Access Compliance Report Public Rights-of-Way (Curb Ramps)

Main Street: N_SKYWOOD_ST Cross Street: BIXBY_AVE Location: NE

ADA ID: RPAT210924124726 Ramp Type: Type 6 - Directional 1 Initial Pass/Fail: Pass Overall Compliance: No Severity Score: 50

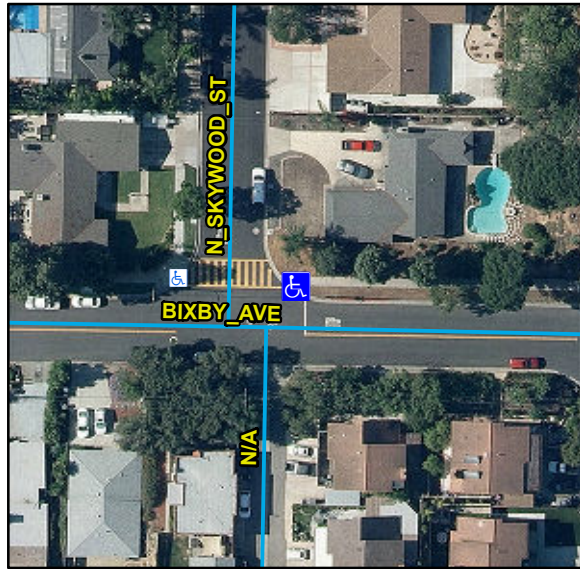
Compliance	Description	Data	Compliance	Description	Data
N/A	Ramp Length (in)	102	N/A	Flare Type LT	
Yes	Ramp Width (in)	48			None
No	Ramp Run Slope (%)	23.5	N/A	Flare Slope LT (%)	N/A
Yes	Ramp Cross Slope (%)	0	N/A	Flare Traversable LT	N/A
No	Grade Break	No	N/A	Flare Type RT	
N/A	Grade Break Slope (%)	N/A			Sloped
N/A	Grade Break Cross Slope (%)	N/A	N/A	Flare Slope RT (%)	N/A
	Addl Para Ramp Left?	No	N/A	Flare Traversable RT	No
	Addl Para Ramp Right?	No	No	DWS Provided	No
N/A	Landing Present	No	N/A	DWS Contrast	N/A
No	Landing Length (in)	N/A	N/A	DWS Length (in)	N/A
No	Landing Width (in)	N/A	N/A	DWS Full Width	N/A
No	Landing Run Slope (%)	N/A		DWS Offset Type	N/A
No	Landing Cross Slope (%)	N/A	N/A	DWS Left Offset (in)	N/A
N/A	Landing Movement Obstructed?	No	N/A	DWS Right Offset (in)	N/A
	Landing Movement Type	N/A			
N/A	Landing Shared	N/A			
N/A	Marked Crosswalk 1	Yes	N/A	Clear Space	N/A
	Crossing 1 Direction	W	N/A	Clear Space To Crosswalk (in)	N/A

Marked Crosswalk 1 Width (in)	120			
No	Ramp Inside Crosswalk 1	No			
	Crossing 1 Slope (%)	11.3			
	Crossing 1 Cross Slope (%)	11			
Yes	Gutter Ponding	No	N/A	Curb Slope	15.5
Yes	Gutter Lip Height (in)	0		Road Run Slope (%)	N/A
No	Gutter Run Slope (%)	-9999		Road Cross Slope (%)	N/A
No	Gutter Cross Slope (%)	-9999		Parallel Ramp Side	N/A
Yes	Overall Surface Condition	Acceptable	Yes	Perp Joint Present	Yes
	Cross Gutter Present?	No		Spandrel Present?	No
	Replace Cross Gutter?	N/A		Replace Spandrel?	N/A

Remove & Replace Entire Ramp. Restripe Crosswalk. Remove & Replace Gutter.
